# INTERNATIONAL BUILDING CODE – GENERAL

**G1-09/10**  
**202, 419.1**

## **Proposed Change as Submitted**

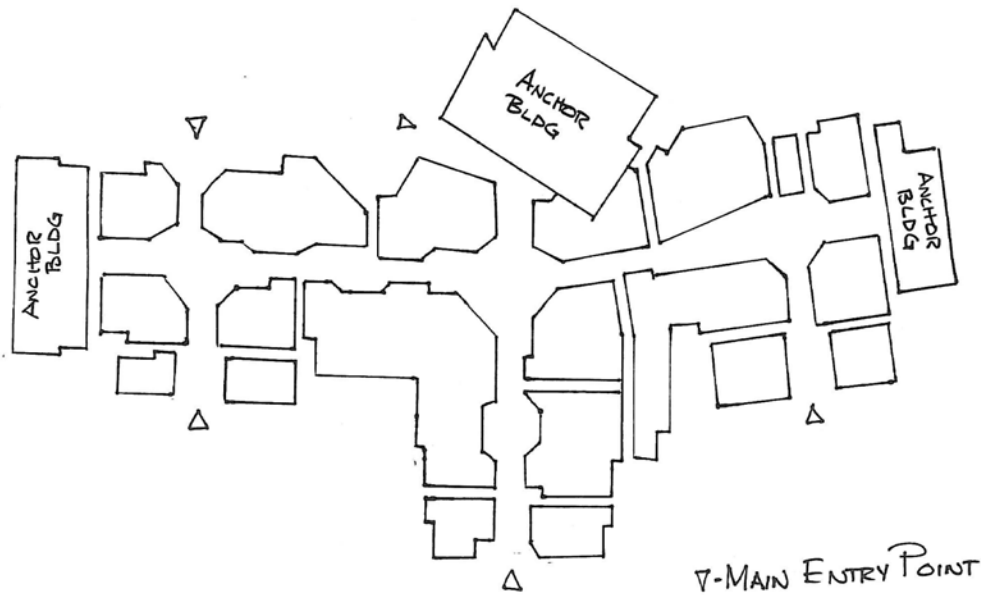
The Committees fundamental reason for disapproving this code change was the need for “additional refinement.” They were concerned by the following:

- the lack of clarity regarding balconies and bridges and the extent to which they could ‘cover’ the open mall;
- the relationship of the perimeter line to the anchor buildings and to the required open area around the open mall building;
- the relationship of the perimeter line with exit discharge as it would appear to permit exit access to dead end where a perimeter line adjoined an anchor building.

To bring clarity to the new provisions for open mall buildings and in response to the committee’s comments the following revisions have been made:

In Section 402.4.3 the redundant language has been addressed.

In Section 402.6 the language has been revised to clarify the sizing of the openings that must be in place for a structure to qualify as an open mall building. It also makes the Exception now a limitation on how pedestrian walkways are to be located in an open mall.

**Open Mall Building  
Without “Perimeter Line”**

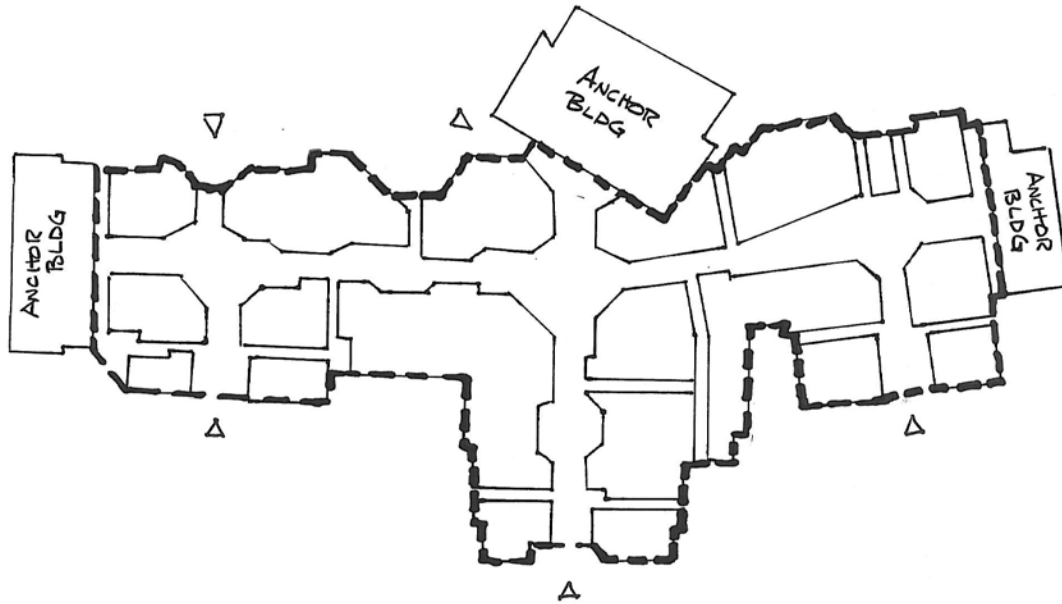
While not noted in the committee reason, there was some concern on where the “perimeter line” would be located. While each open mall building will be unique, the diagrams shown below is an example of how the various structures that typically make up an open mall building would be laid out, and then how the “perimeter line” would be situated around the structures. The designer will have the discretion as to the relative location of the “perimeter line,” similar to the discretion they have to place an imaginary line for purposes of determining the “fire separation distance” when two buildings are located on the same lot. But even with that discretion, it is anticipated that the “perimeter line” created for an open mall building will in essence enclose the same space as exterior walls would in a covered mall building.
